Attention: NHTSA Docket ID No. NHTSA-2018-0067  
U.S. EPA Docket ID No. EPA-HQ-OAR-2018-0283

Re: Safer Affordable Fuel-Efficient (SAFE) Vehicles Rule for Model Years 2021-2026 Passenger Cars and Light Trucks

Figure 1: Comparison of Draft TAR and NPRM/PRIA Total Mass Reduction Costs

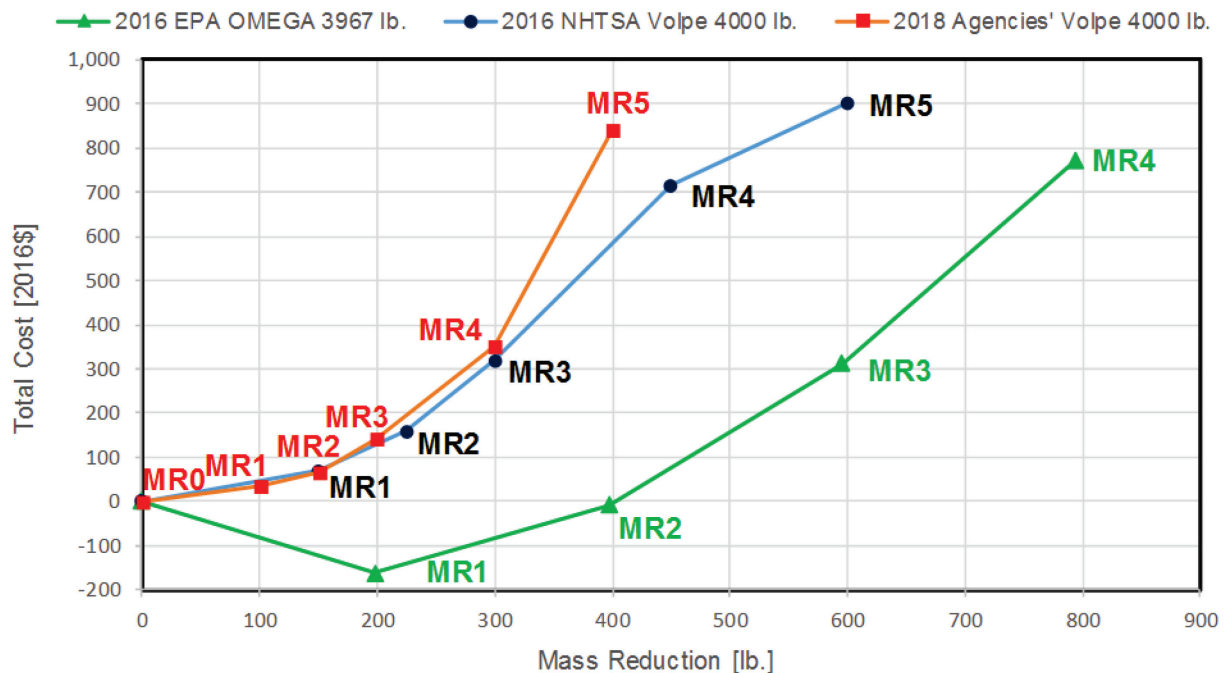
As shown in Table 1 below, the mass reduction costs used in the 2018 rulemaking are much higher than the Alliance reports. Furthermore, Figure 1 below shows that the costs NHTSA used in 2016 are also greater at higher levels of mass reduction.
